## MASSACHUSETTS INSTITUTE OF TECHNOLOGY CAMBRIDGE, MASS. 02139

Subject: M.I.T. - Data Switch

Attached is the current grading sheet on level "8" - MULTICS.

GRADED MULTIPLE ARRANGEMENT - 8th LEVEL TO I.B.M. 1050 MAC

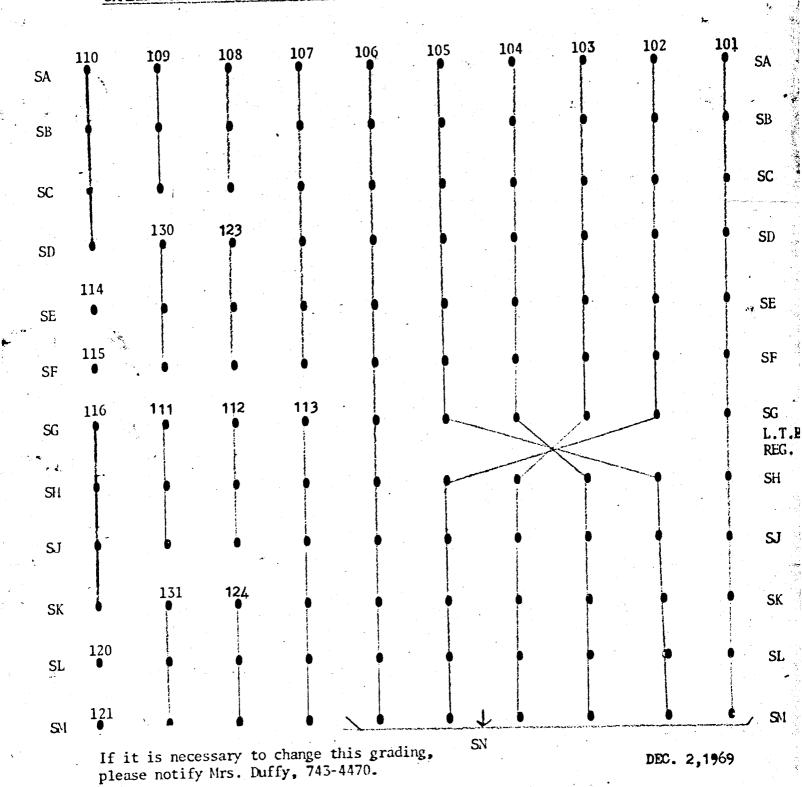
The grade takes into consideration the matters concerning the trunks we previously discussed. In addition:

- Trunks 111-2-3, and 123-4 were on selector shelves which tended to be the last choices for selection. This was due both to the amount of traffic generated by the associated station line groups and the "start lead" chain.
  - · Trunk 132 was malfunctioning and has been repaired.
  - \* Trunk 128 was transposed with 129, and this was corrected.

The new grade should correct the balance of usages among the trunks. I would appreciate your comments on this.
